## Service Bulletin

Model #: ER48D/ER36D/ER30D

DATE 08/10/09

Product Description: ERC CONTROLLER UPGRADE / HEAT MAINTENANCE

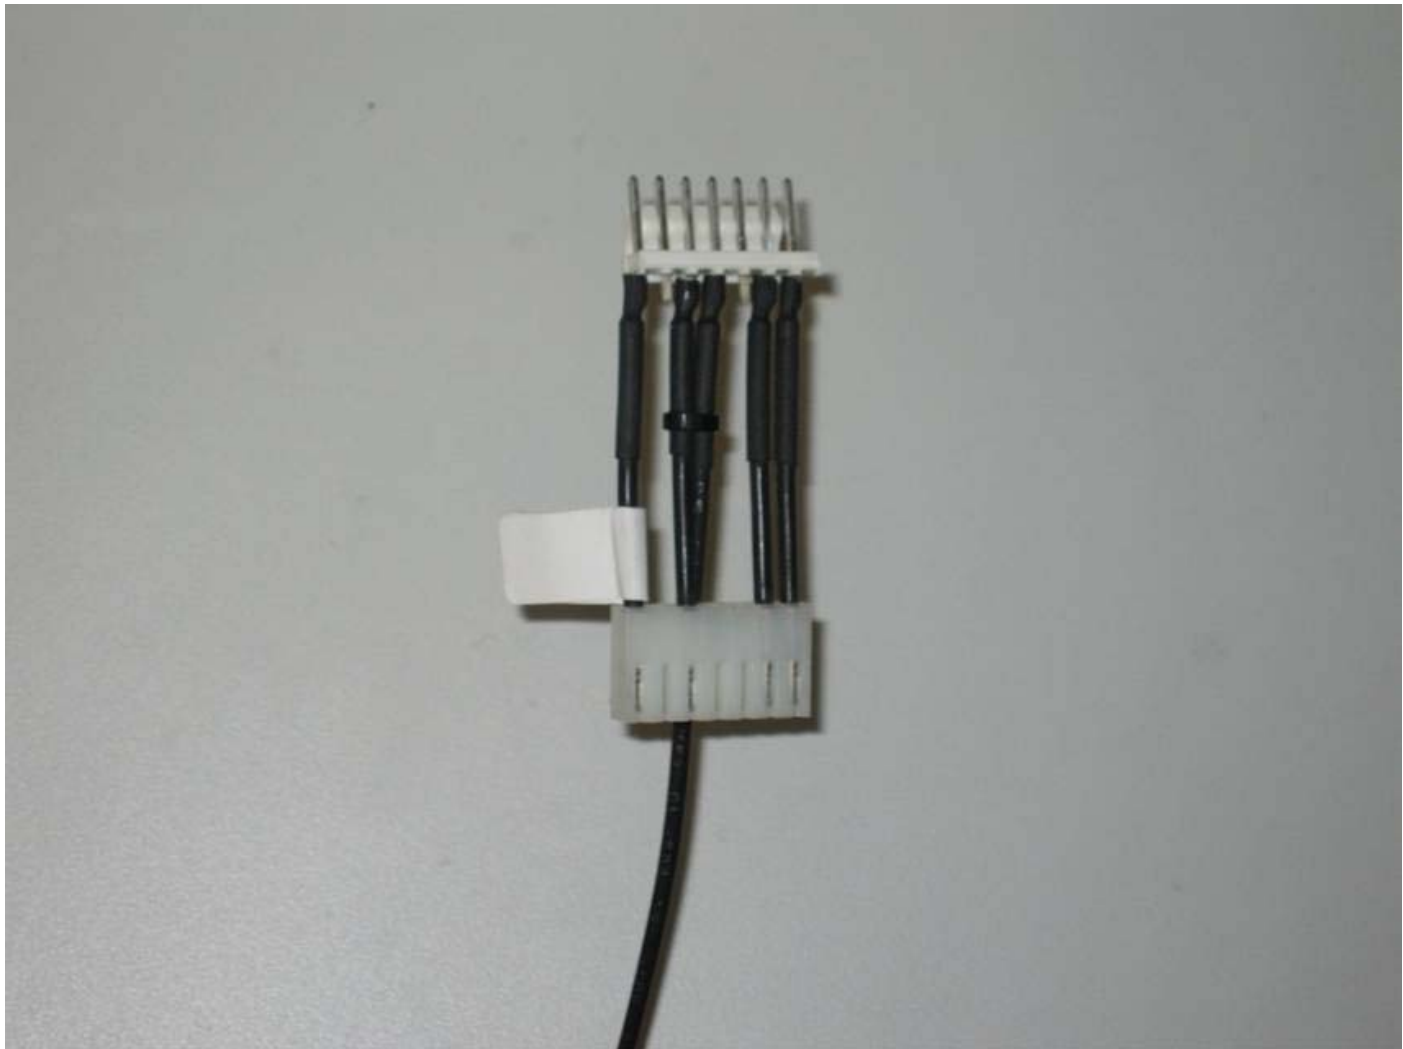
**Note: The DACOR CE/CF ADAPTOR HARNESS WAS NOT USED ON ALL UNITS. IF THERE IS NOT A HARNESS THE NEW CONTOLLER REPLACMENT IS A STRAIGHT CHANGE OUT THE PICTURE BELOW SHOW THE " DACOR CE/CF ADAPTOR" THAT NEEDS TO BE REMOVED AND DISCARDED.**

8. Remove the relay access cover between the center burner bases.
9. Unplug connector of the relay board at P33 and remove the DACOR CE/CF ADAPTOR HARNESS and reconnect original harness back onto P33. Remove the orange wire and black from the quick connector at P4 on relay board. Pull the orange wire off the black dual quick connection and reconnect the orange wire to the relay board at P4 discard the black quick connection.
